## ADDENDUM NO. 1

Date of Issue: October 12, 2018

To all prospective bidders on the Work titled: Robles Diversion Canal Maintenance (FY 18-19) (Specification No. 18-405).

- Robles Diversion Canal
  - Water Supply Locations
- Diversion Canal Replacement Project- Figure 1

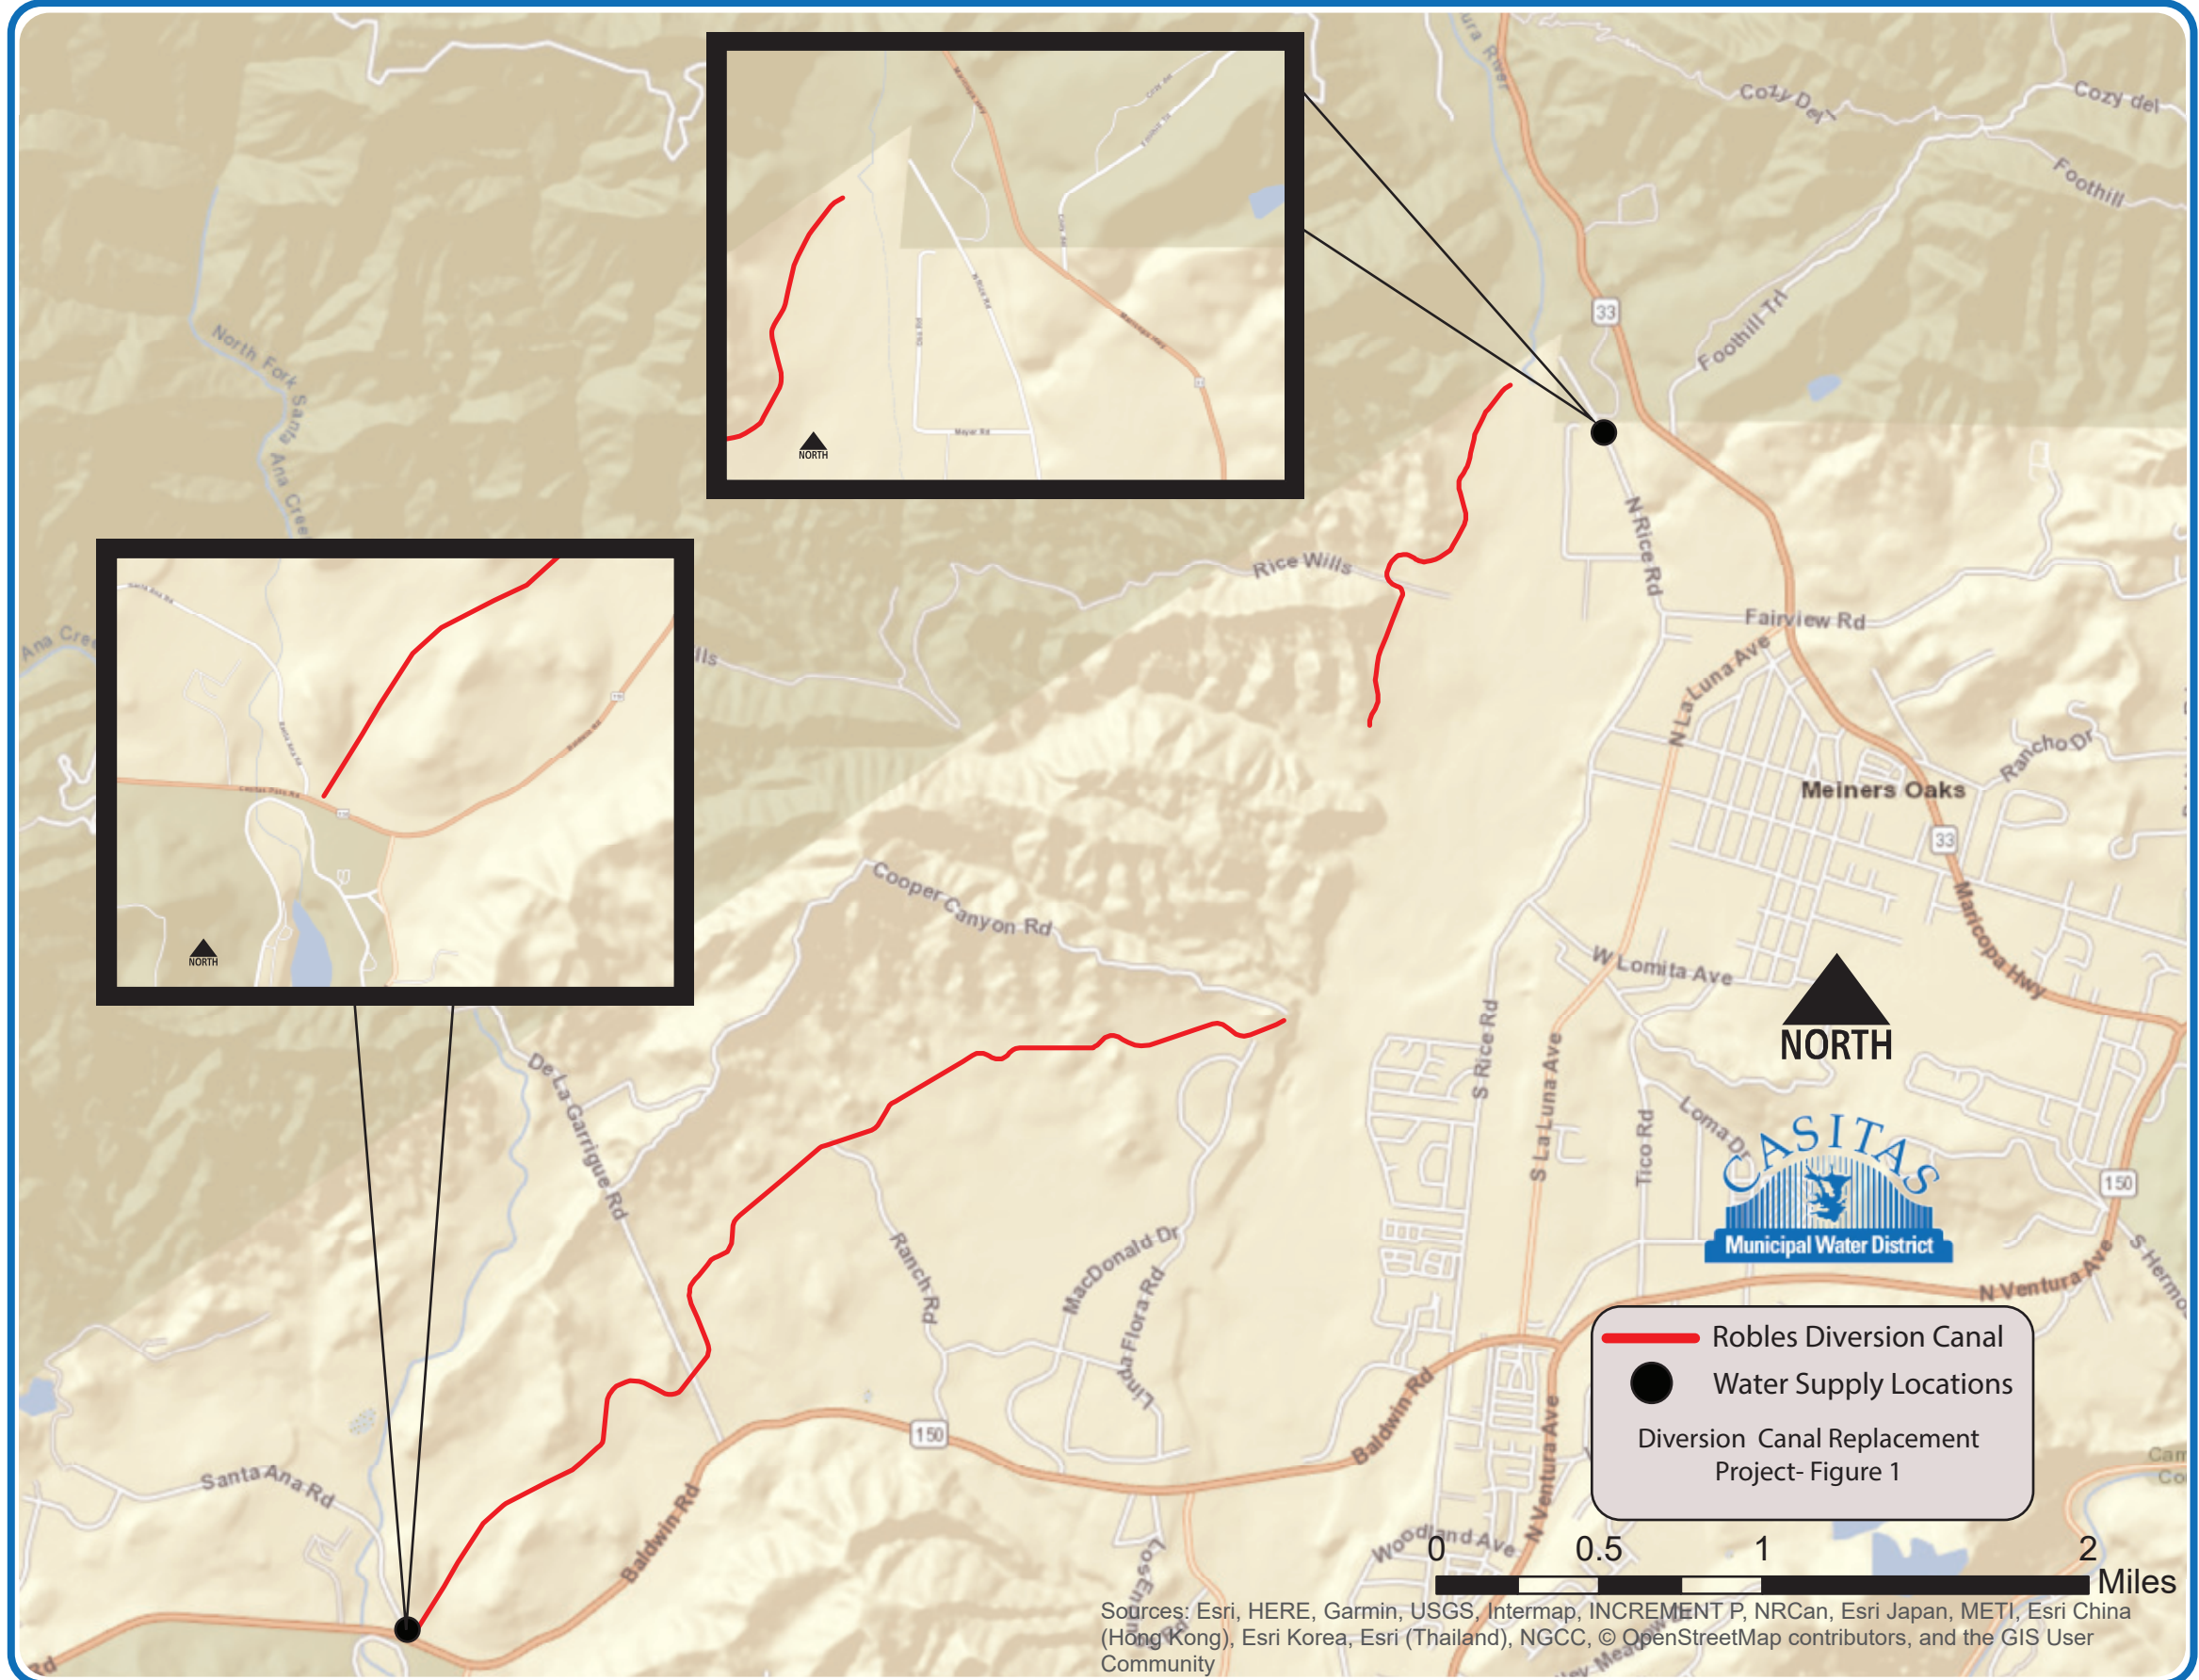
Per page 77 of Specification, water will be provided by the district. Can you please give location for this source?

- Response: The purpose of the canal is to collect water and direct downstream. No ramifications are foreseen.
- Question 14: Will we be able to use local fire-hydrants for re-filling our water truck free of charge?

The location is shown in Figure 1 below.

- Response: There are two potential filling station locations for water use. See attached Figure 1 for reference. The water will be free of charge. A construction meter must be checked out from the District office for the duration of work at no cost to the Contractor.
